Subject: Class 3 Permit Modification Request for the Waste Isolation Pilot Plant Hazardous Waste Facility Permit, Number NM4890139088-TSDF and Notification of Withdrawal Regarding the December 22, 2017 Determination of Class

Class 3 Permit Modification Request

Excavation of a New Shaft and Associated Connecting Drifts

**Waste Isolation Pilot Plant
Carlsbad, New Mexico**

Figure A2-1
Repository Horizon

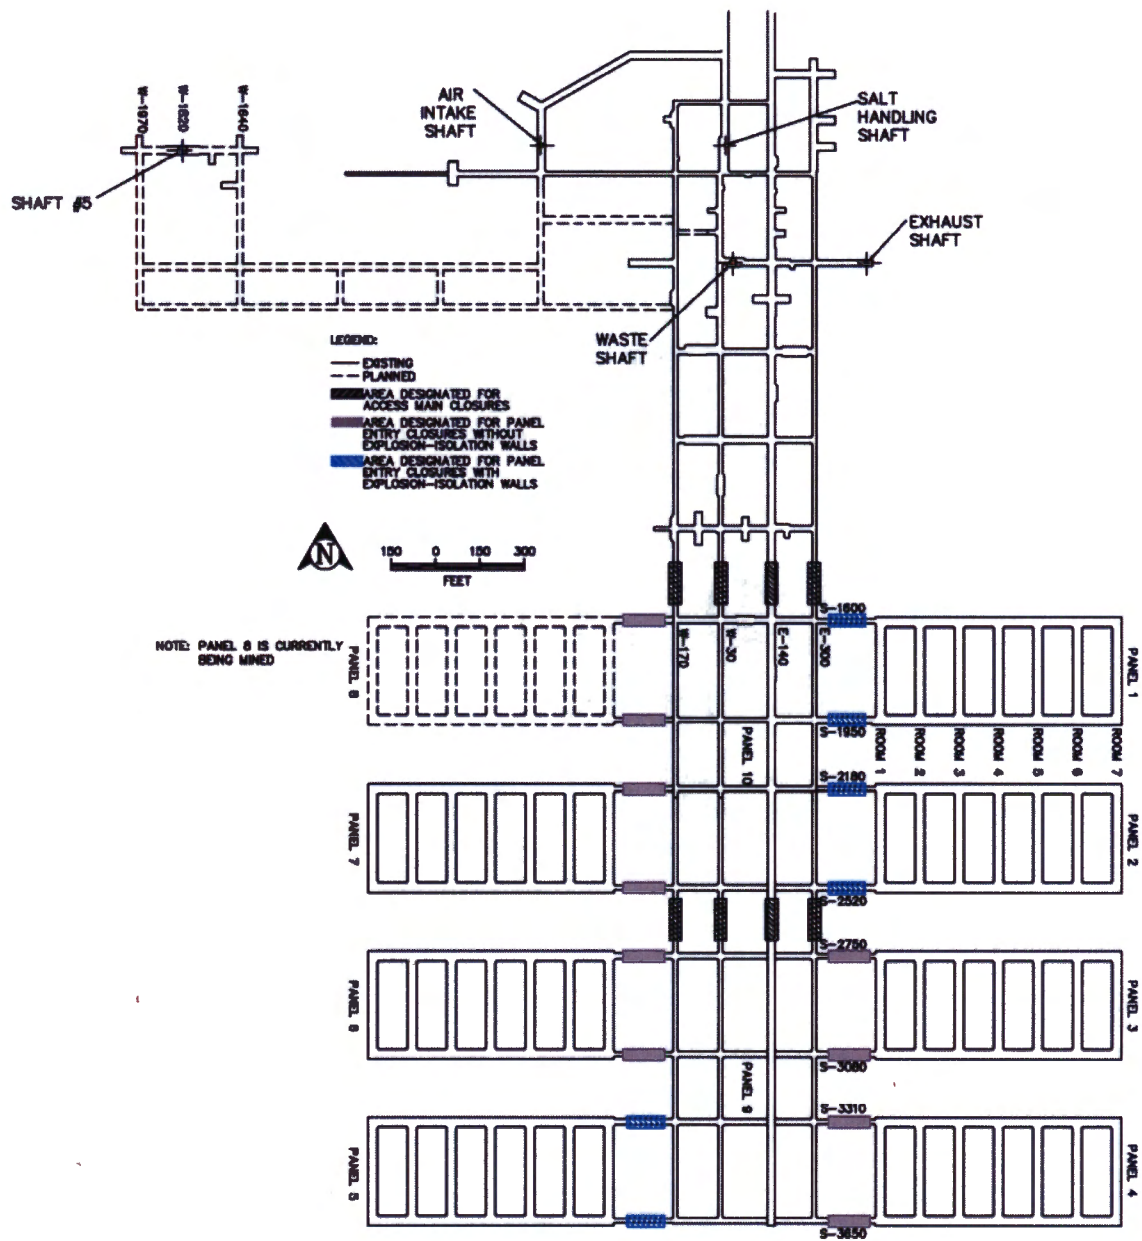
Affected Permit Section	Explanation of Change
Attachment A2, Figure A2-1	Replaced Figure A2-1 <i>Repository Horizon</i> with new figure.
Attachment A2, Figure A2-2-S#5	Added new Figure A2-2-S#5, <i>Spatial View of the Miscellaneous Unit and Waste Handling Facility (with S#5)</i> , after Figure A2-2.
Attachment A2, Figure A2-9c	Added new Figure A2-9c, <i>Underground Ventilation System Airflow (with S#5)</i> , after Figure A2-9b.
Attachment A4, Figure A4-4	Replaced Figure A4-4, <i>Typical Underground Transport Route Using E-140</i> , with new figure.
Attachment A4, Figure A4-4a	Replaced Figure A4-4a, <i>Typical Underground Transport Route Using W-30</i> , with new figure.
Attachment B, Table of Contents	Added entry for Figure B3-1-S#5, <i>Spatial View of the WIPP Facility (with S#5)</i> , to Table of Contents, Appendix B3 Facilities.
Attachment B, Appendix B2, Figure B2-2	Replaced Figure B2-2, <i>Planimetric Map-WIPP Facility Boundaries</i> , with new figure.

Figure A2-2-S#5
Spatial View of the Miscellaneous Unit and Waste Handling Facility (with S#5)

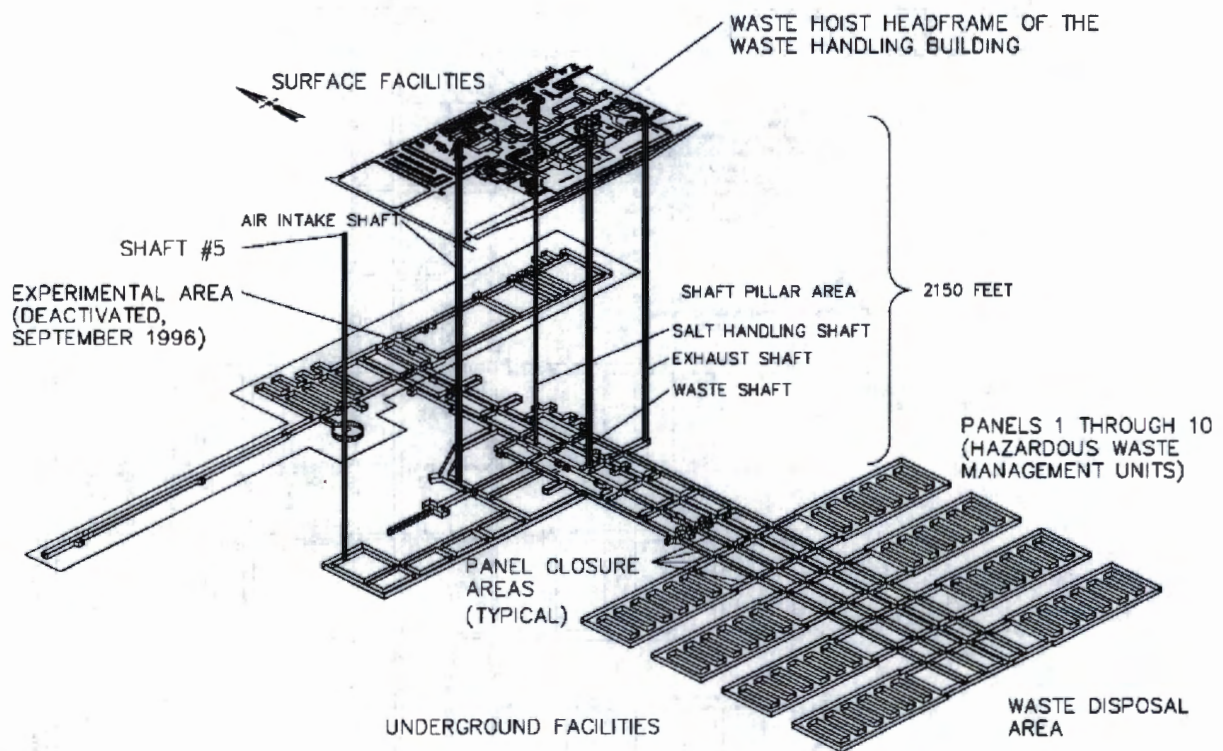
Attachment A2, Figure A2-2-S#5	The <i>Spatial View of the Miscellaneous Unit and Waste Handling Facility (with S#5)</i> figure is being added to show the location of S#5 and the planned connecting drifts in relation to the existing underground facility. This change is needed to update the Permit with the information pertaining to S#5.
Attachment A2, Figure A2-9c	Figure A2-9c, <i>Underground Ventilation System Airflow (with Shaft #5)</i> is being added to show the repository ventilation flow with S#5. This change is needed to update the Permit with the information pertaining to S#5.
Attachment A4, Figure A4-4	The <i>Typical Underground Transport Route Using E-140</i> figure is being modified to show the location of S#5 along with the planned drifts to connect the shaft to the underground facility. This change is needed to update the Permit with the information pertaining to S#5.
Attachment A4, Figure A4-4a	The <i>Typical Underground Transport Route Using W-30</i> figure is being modified to show the location of S#5 along with the planned drifts to connect the shaft to the underground facility. This change is needed to update the Permit with the information pertaining to S#5.

Figure A2-9c
Underground Ventilation System Airflow (with S#5)

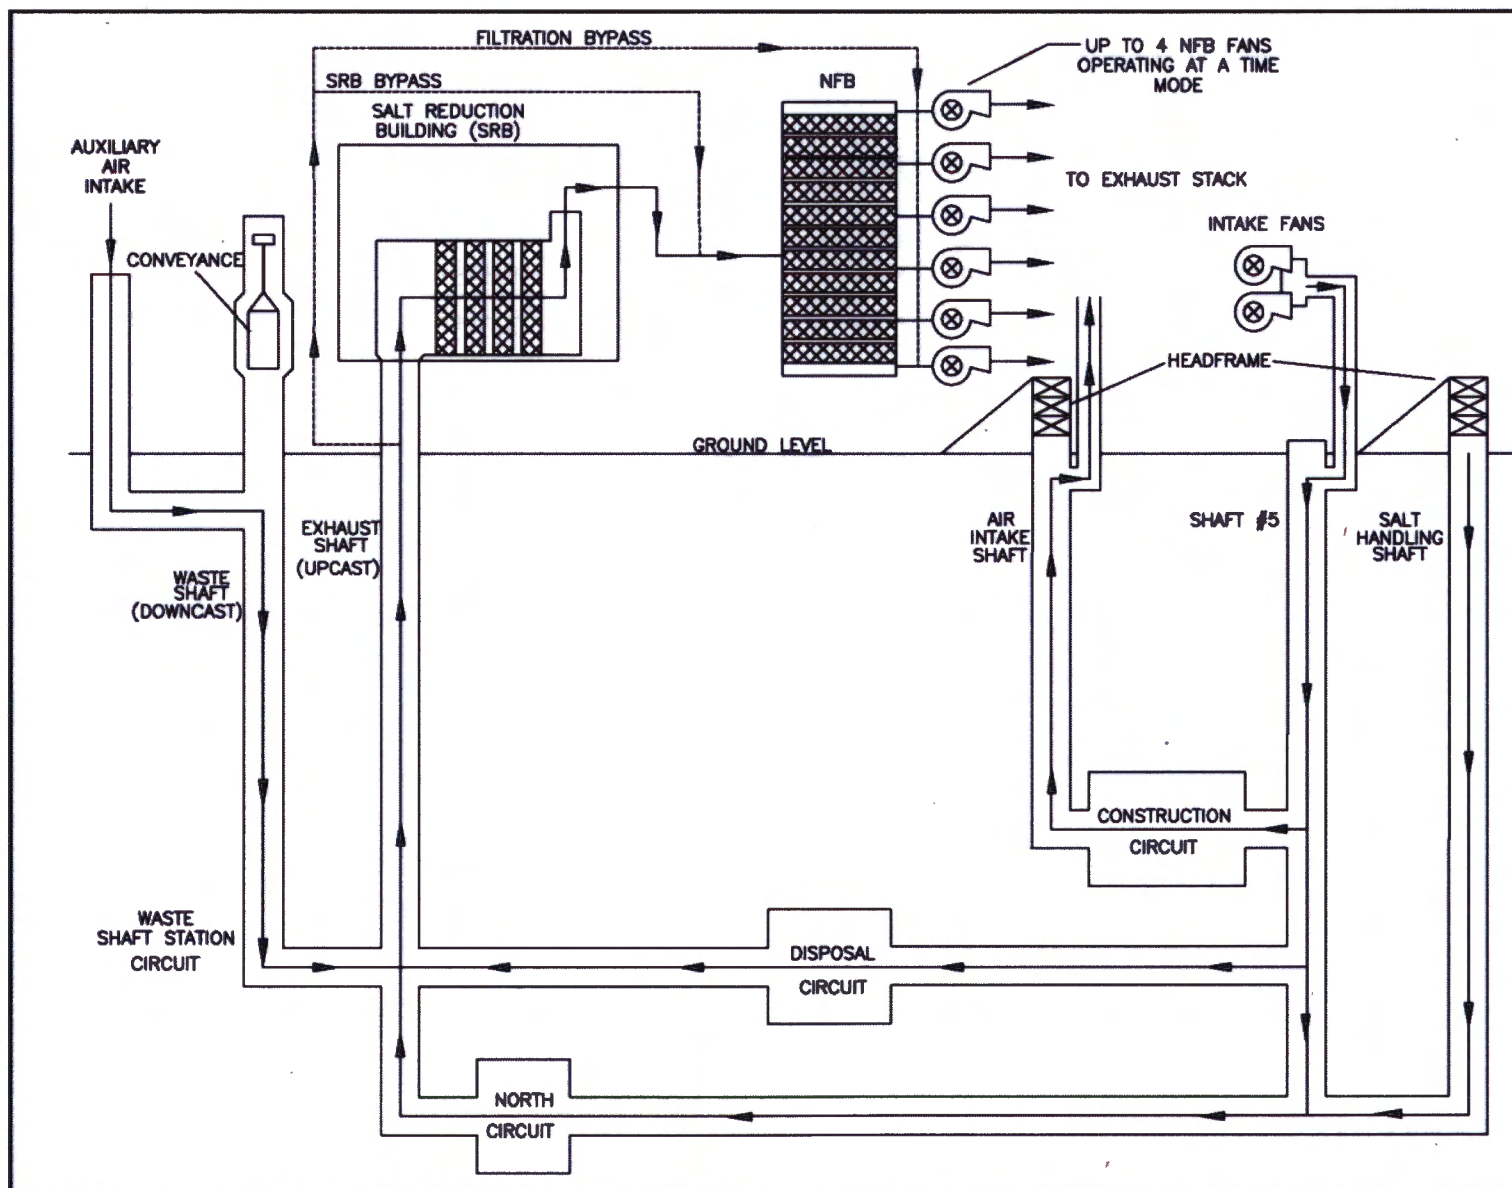
Attachment A2, Section A2-2a(3), <i>Subsurface Structures</i>	<p>Added new paragraph "With S#5 in use (Figure A2-9c), the Salt Handling Shaft serves as the secondary supply-air pathway for the underground facility while S#5 serves as the primary supply-air pathway for the underground facility. The Waste Shaft supplies the intake air for the Waste Shaft Station. The Air Intake Shaft provides the exhaust route for the Construction Circuit while the Exhaust Shaft provides the exhaust route for the North, Disposal, and Waste Shaft Station Circuits." after second paragraph under subsection <i>Underground Facilities Ventilation System</i>.</p> <p>Added new paragraph "When the repository is configured to use five shafts, two fans located on the surface and connected via ducting and a plenum to S#5, supply the majority of the intake air to the underground facility. One fan operates at a time, while the idle fan is available as a back-up fan. The Salt Handling Shaft serves as a secondary air intake shaft for the north area and the Waste Shaft serves as the air intake shaft for the waste shaft station area of the underground facility. The Air Intake Shaft serves as an unfiltered exhaust shaft for the construction area of the underground facility. The north, disposal, and waste shaft station areas of the underground facility are exhausted through the Exhaust Shaft and the associated filtration system." after first paragraph under subsection <i>Underground Ventilation System Description</i>.</p> <p>Added "standard" after "minimum ventilation rate of 35,000."</p> <p>Added "When the repository is configured to use four shafts," to the first paragraph under subsection <i>Underground Ventilation Modes of Operation</i>.</p> <p>Added new paragraph "When the repository is configured to use five shafts, two intake fans located on the surface and connected to S#5 via ducting and a plenum, supply the majority of the intake air to the underground facility. The fans are designed to operate one fan at a time with the second fan available as a back-up fan. The fans have variable frequency drives that can adjust the intake flow at S#5 to meet the requirements of the underground ventilation filtration system and the Construction Circuit." after third set of bullets under subsection <i>Underground Ventilation Modes of Operation</i>.</p>

Figure B2-2
Planimetric Map-WIPP Facility Boundaries

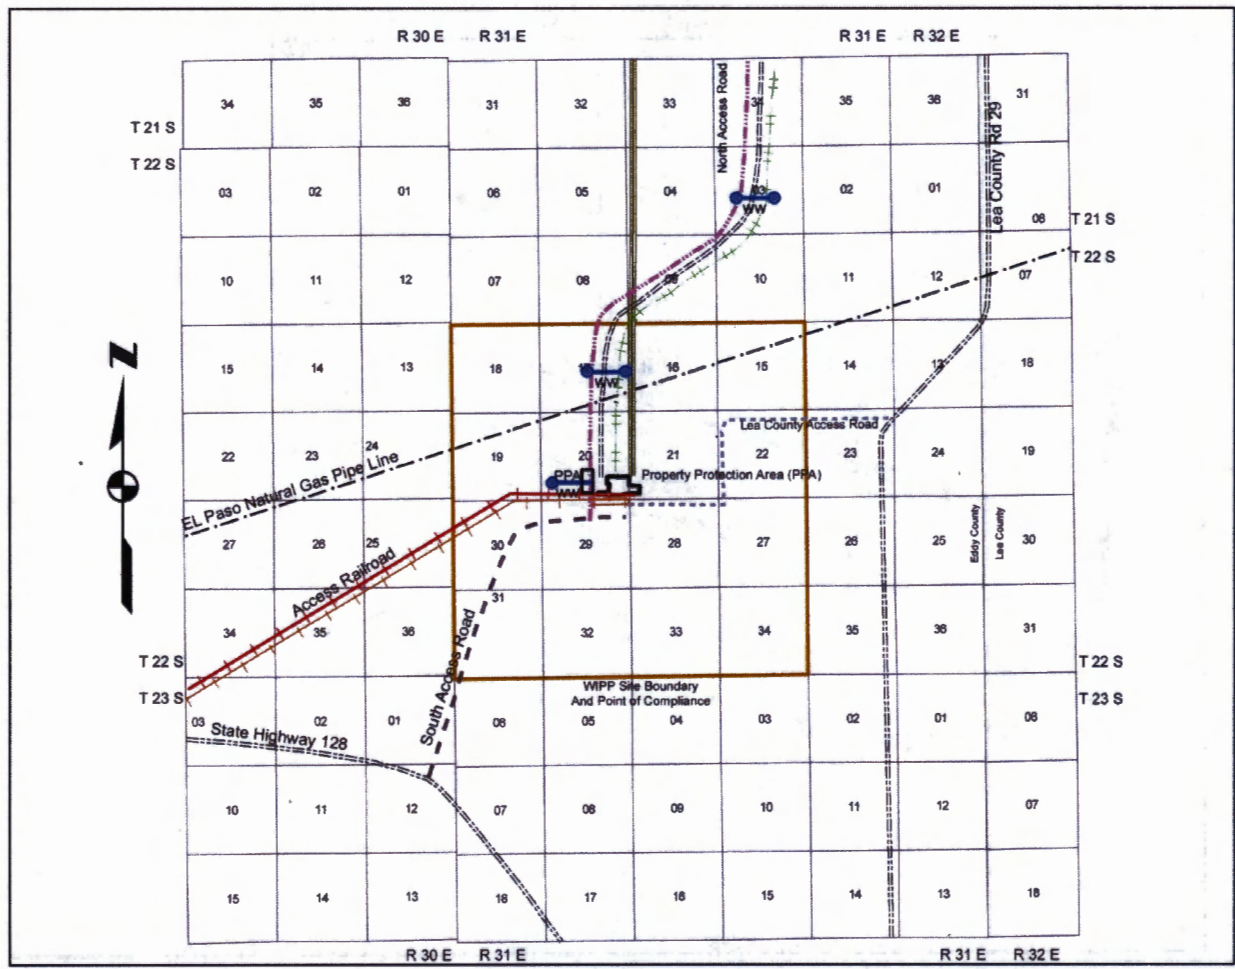
- A nominal 22-acre Property Protection Area (**PPA**) encompassing the area around S#5 will be added to the property description in Permit Attachment A. Permit Attachment B, Figure B2-2, *Planimetric Map-WIPP Facility Boundaries* and Figure B2-2a, *Legend to Figure B2-2* are being replaced to show the additional PPA, estimated acreage around S#5, and to make corrections and editorial changes.

Attachment B, Figure B2-2	The <i>Planimetric Map-WIPP Facility Boundaries</i> figure is being modified to show the additional PPA around S#5. This change is needed to update the Permit with the information pertaining to S#5.
Attachment B, Figure B2-2a	The <i>Legend to Figure B2-2</i> figure is being modified to describe the additional PPA area around S#5 in the "Notes" section of the figure. This change is needed to update the Permit with the information pertaining to S#5.
Attachment B, Figure B3-1-S#5	The <i>Spatial View of the WIPP Facility (with S#5)</i> figure is being added to show the spatial view of the facility with S#5 and the planned connecting drifts. This change is needed to update the Permit with the information pertaining to S#5.
Attachment B, Figure B3-2	The <i>Repository Horizon</i> figure is being modified to show the location of S#5 along with the planned drifts to connect the shaft to the underground facility. This change is needed to update the Permit with the information pertaining to S#5.

Figure B3-1-S#5
Spatial View of the WIPP Facility (with S#5)

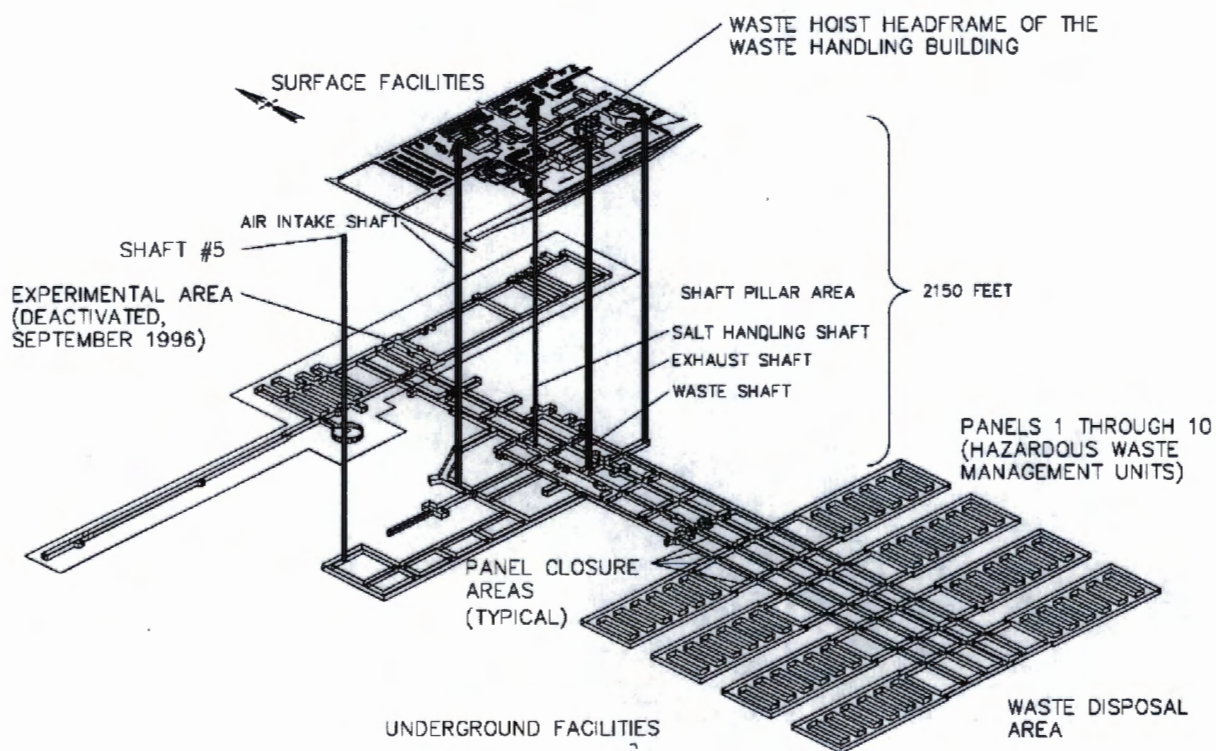
Attachment B, Appendix B2, Figure B2-2a	Replaced Figure B2-2a, <i>Legend to Figure B2-2</i> , with new figure.
Attachment B, Appendix B3, Figure B3-1-S#5	Added new Figure B3-1-S#5, <i>Spatial View of the WIPP Facility (with S#5)</i> , after Figure B3-1.
Attachment B, Appendix B3, Figure B3-2	Replaced Figure B3-2, <i>Repository Horizon</i> , with new figure.
Attachment D, List of Figures	Added entries for Figure D-2-S#5, <i>Spatial View of the WIPP Facility (with S#5)</i> , and Figure D-5-S#5, <i>Fire-Water Distribution System (with S#5)</i> , to Table of Contents.
Attachment D, Figure D-2-S#5	Added new Figure D-2-S#5, <i>Spatial View of the WIPP Facility (with S#5)</i> , after Figure D-2.
Attachment D, Figure D-3	Replaced Figure D-3, <i>WIPP Underground Facilities</i> , with new figure.
Attachment D, Figure D-5-NFB	Replaced Figure D-5-NFB, <i>Fire-Water Distribution System with Building 416</i> , with new figure.

Figure D-2-S#5
Spatial View of the WIPP Facility (with S#5)

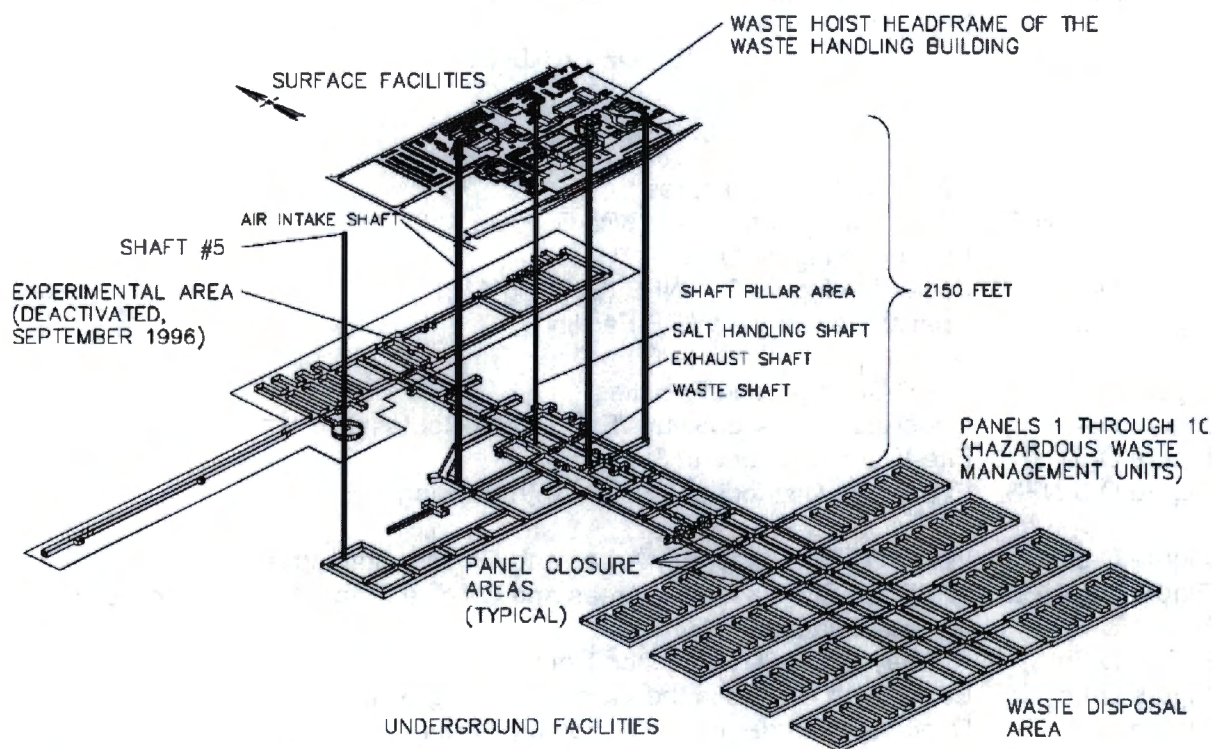
Attachment D, Figure D-2-S#5	The <i>Spatial View of the WIPP Facility (with S#5)</i> figure is being added to show the location of S#5 and the planned connecting drifts in relation to the existing underground facility. This change is needed to update the Permit with the information pertaining to S#5.

Figure D-3
WIPP Underground Facilities

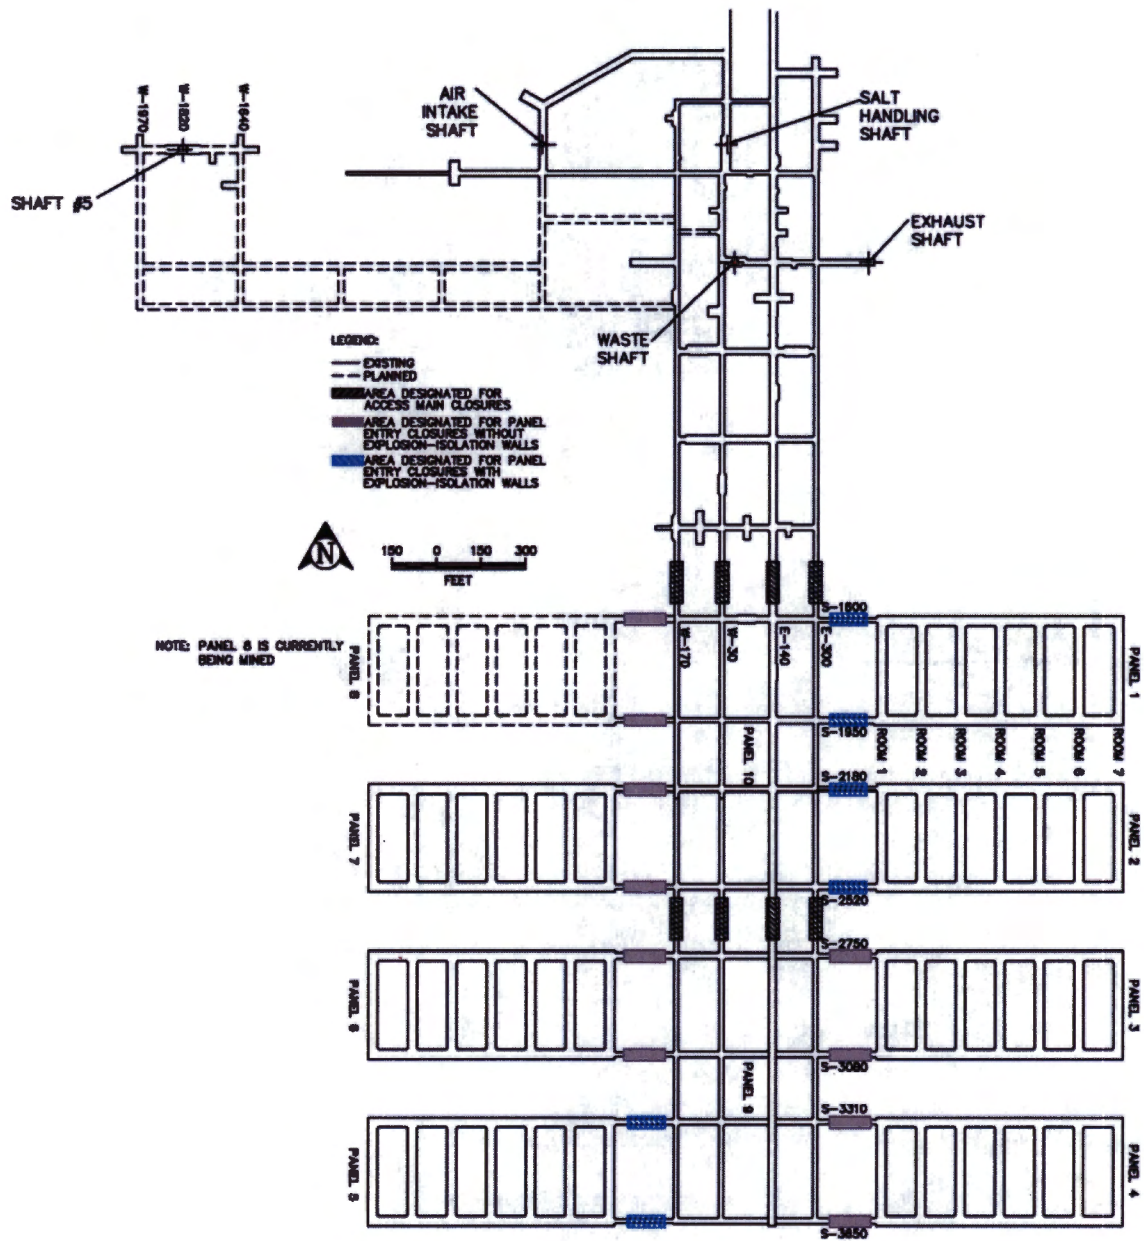
Permit Part/Section	Impact
Attachment D, Figure D-3	The <i>WIPP Underground Facilities</i> figure is being modified to show the location of S#5 along with the planned drifts to connect the shaft to the underground facility. This change is needed to update the Permit with the information pertaining to S#5.
Attachment D, Figure D-5-NFB	The <i>Fire-Water Distribution System with Building 416</i> figure is being replaced to show the fire-water loop extending to the S#5 area. This change is needed to update the Permit with the information pertaining to S#5.
Attachment D, Figure D-5-S#5	The <i>Fire-Water Distribution System (with S#5)</i> figure is being added to show the fire-water loop around the S#5 area. This change is needed to update the Permit with the information pertaining to S#5.
Attachment D, Figure D-7	The <i>Designated Underground Assembly Areas</i> figure is being modified to show the location of S#5 along with the planned drifts to connect the shaft to the underground facility. This change is needed to update the Permit with the information pertaining to S#5.
